GFA AD 416
(ISSUE 1)

GFA AIRWORTHINESS DIRECTIVE

BACKGROUND: Overseas Experience has shown that moisture may enter the vertical elevator pushrod in the fin and cause corrosion and possible failure of the pushrod. Note: This AD is a powered sailplane version of AD 415.

<u>Subject</u> :	Vertical elevator actuating rod inside the fin																												
<u>Affected</u> :

Load testing the elevator control system

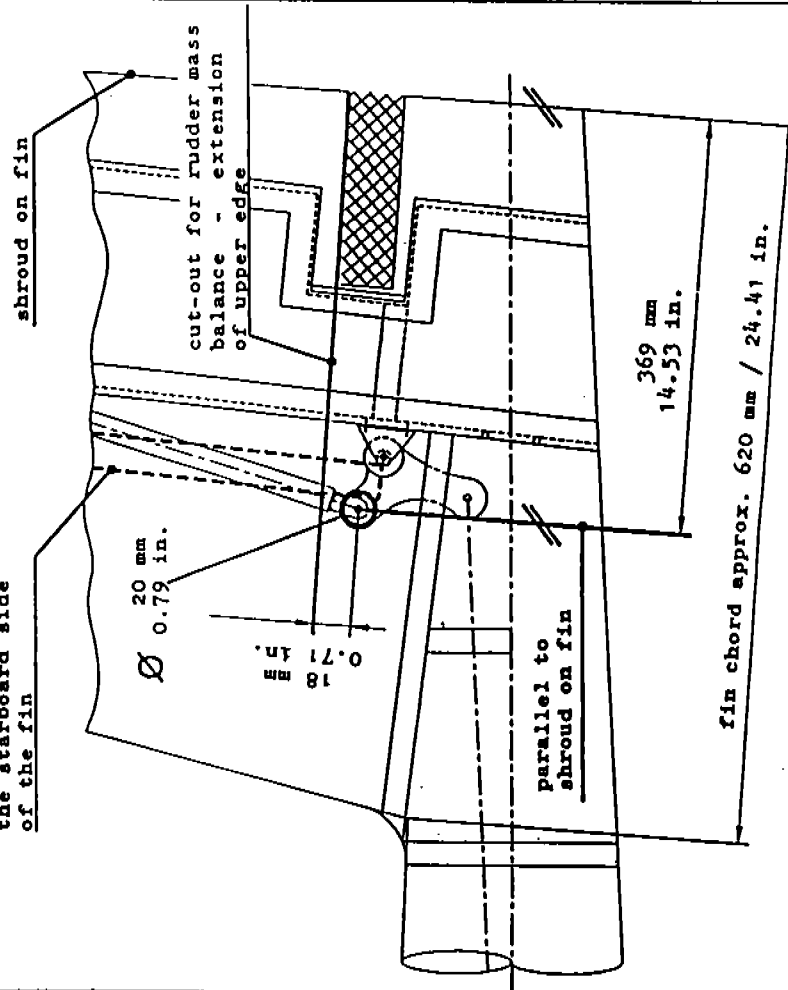
1. Position a solid steel rod or a steel tube (∅ 12 to 16 mm/ 0.47 to 0.63 in.) between the elevator actuating lever and the skin of the fin projecting above the end rib.

2. Pull back control stick via a dynamometer or spring scale (attached at the middle of the stick handle) up to a force of 210 N ± 21 daN (46.3 lb), maintain this load for one (1) second and release stick.

3. Mount horizontal tailplane and check elevator for proper function with the aid of a helper (elevator fixed, move stick fore and aft).

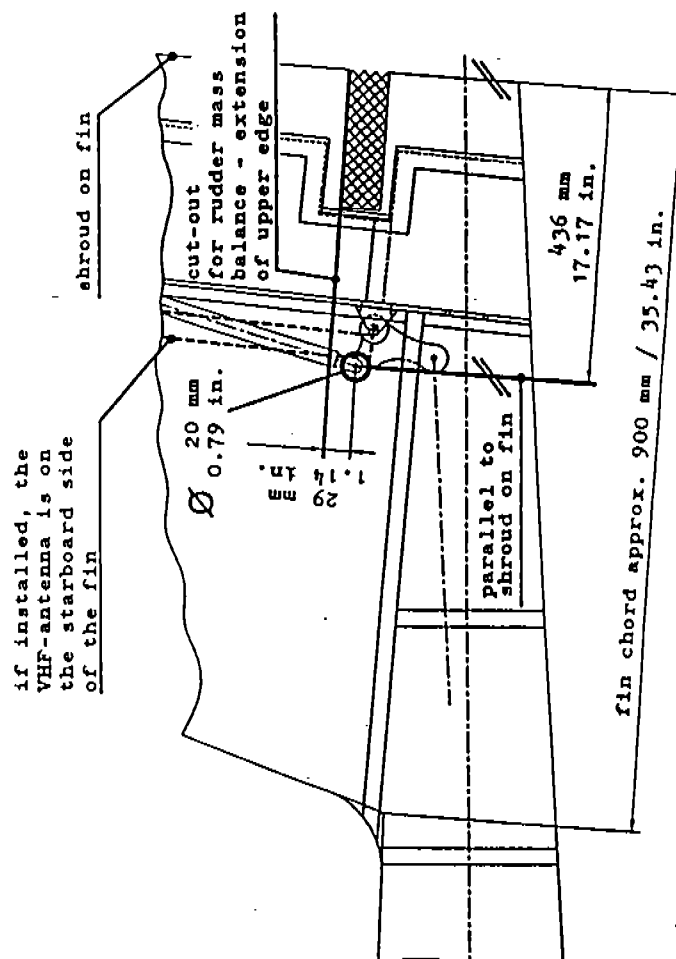
Dimensions shown below are applicable to the following models:

Nimbus-3DT, Nimbus-3DM
Janus CT

Notes: Prior to drilling the openings into the fin,
measure its chord for compliance with the sketch
(see also page 3)
